Docket Item #5  
BAR CASE #2006-0161

BAR Meeting  
April 25, 2007

**ISSUE:** New residential building  
**APPLICANT:** Anna Maria & Michael Dechert  
**LOCATION:** 804 Pendleton Street  
**ZONE:** RB Residential

**Figure 2 - Proposed plan**

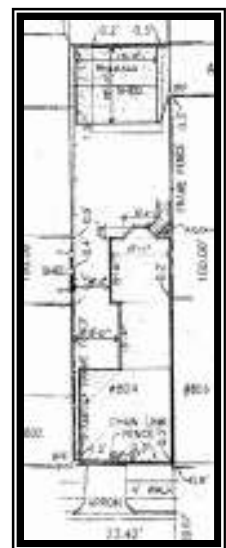
The proposed house will be composed of three sections. The front block is square in plan. It will abut the house at 806 Pendleton Street on the west side and extend across nearly the entire width of the lot and leaving 11" between the wall and the property line on the east side. The narrower middle section will be rectangular in plan. It will also abut the house at 806 Pendleton Street on the west side and will be set back 11' from the east property line. The rear section is wider than the middle section and square in plan. It will be set back 8' from the east property line and will extend beyond the house at 806 Pendleton Street on the west side. The house will be 55'4" long. The heights of the various sections of the house have been reduced and revised following the City Council hearing. The height of the house will be 24'10" high at the front block (reduced from 28'10") and will step down in height thence with the middle section being approximately 24'1" (reduced from 27'1"), the rear section now proposed to be 23'4" (reduced from 25'10"), and the bay 22'10". The house will be two stories with a raised basement and a flat roof (the

mansard roof previously shown has been deleted). It will be constructed of CMU. The main block of the house will be clad in brick on the north (front), east (side) and south (rear) facades. (A brick sample will be made available to the Board at the hearing.) All other facades will be stucco. There will be wood trim, wood windows, wood doors and round metal down spouts and half round metal gutters. The windows will be simulated divided light windows by Pella, Kolbe and Kolbe or equivalent. The window sills and lintels in the brick clad block will be brick soldier courses. The sills and lintels in the stuccoed portions will be projecting masonry with stucco finish.

**Figure 3 - Proposed front (north) elevation**

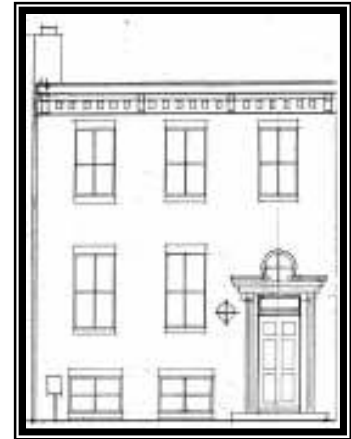
The front (north) elevation will appear as a two story house with a full flat roof and raised basement. The front door will be on the right side of the elevation at street level. The door will be a four-panel door as shown on the detail sheet, rather than six panel. It will be set within a heavy door surround with a rectangular transom and an oculus window above. A globe shaped, surface mounted light fixture will be located to the left of the door. A single step brick stoop will lead to the door. There will be two, four-light windows to the left of the door lighting the basement level, which will be partially below grade. As revised, the basement windows will be at grade and will not have window wells. The first story will have two, two-over-two

windows to the left of the door. These windows will be approximately 5.5' in height. The window height will be slightly less in the second story where there will be three evenly spaced two-over-two windows. There will be a wood cornice with brackets and dentils at the base of the flat roof. The cornice will extend around all but the west elevation. There will be a gutter across the front and downspouts at either corner. The electrical meter will be located just above grade at the left side of the front elevation.

**Figure 4 - Proposed side (west) elevation**

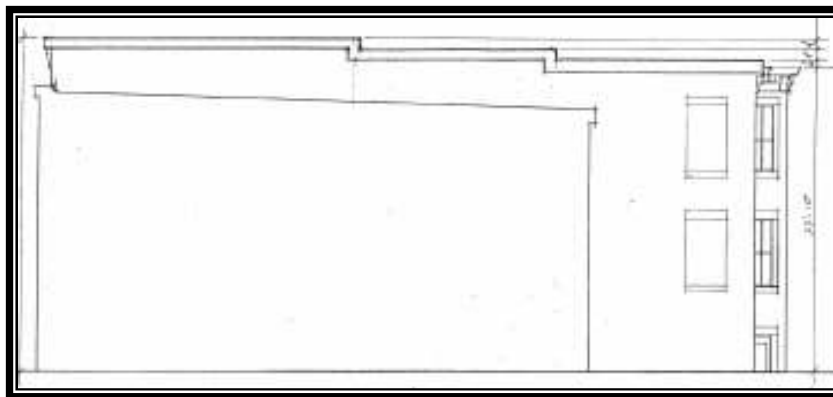
The 55'4" long west elevation will be partially obscured by the adjacent houses at 806 and 808 Pendleton Street. The rear 15' of the proposed house will extend beyond the neighboring houses at 806 and 808 Pendleton Street and will be visible in oblique views from Pendleton Street and the alley. It may also be partially visible from Alfred Street. The narrow sliver of wall visible above 806 Pendleton Street will be clad in metal flashing to ensure that the joint between the

new and existing house is watertight. The back section of the proposed house that extends beyond 806 and 808 Pendleton Street will be covered in stucco. There will be two rectangular areas inset approximately 1" to suggest blind windows at the south end of this section on the first and second stories. The inset areas will have sills and headers and will be stuccoed.
